PARTS & SERVICE NEWS

REF NO. A950048B

SUBJECT: IMPROVEMENT OF TRANSMISSION OIL FILTER CLOG SENSOR

APPLICATION: 558 Wheel Loader, S/N 006001 and up
568 Wheel Loader, S/N 007001 and up
WA500-1 Wheel Loader, S/N 10001 thru 21096 and A20001 thru A20266
WA500-1L Wheel Loader, S/N A20267 and up
WA500-1LC Wheel Loader, S/N A60001 and up
WA600-1 Wheel Loader, S/N A10001 thru A10139
WA600-1L Wheel Loader, S/N A10140 and up
WA600-1LC Wheel Loader, S/N A50001 and up

Section of transmission oil filter

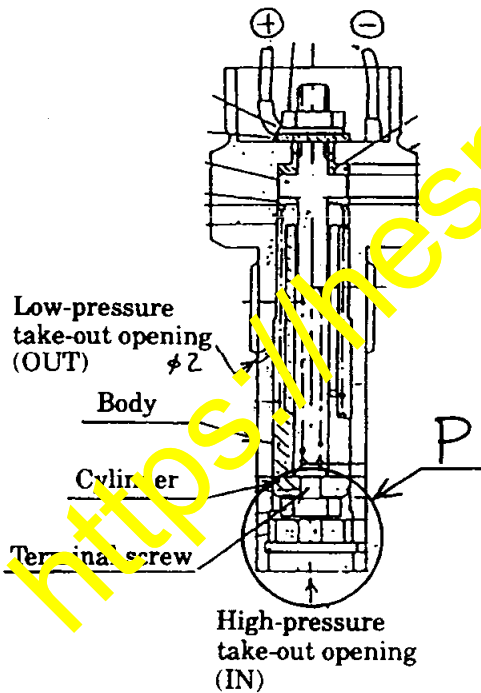
A 150-mesh strainer is added to the high-pressure port of the transmission oil filter clogging sensor to prevent dust from entering the contact area in the sensor and the cylinder.

4. Repair procedure
Replace the clogging sensor installed to the transmission oil filter head.
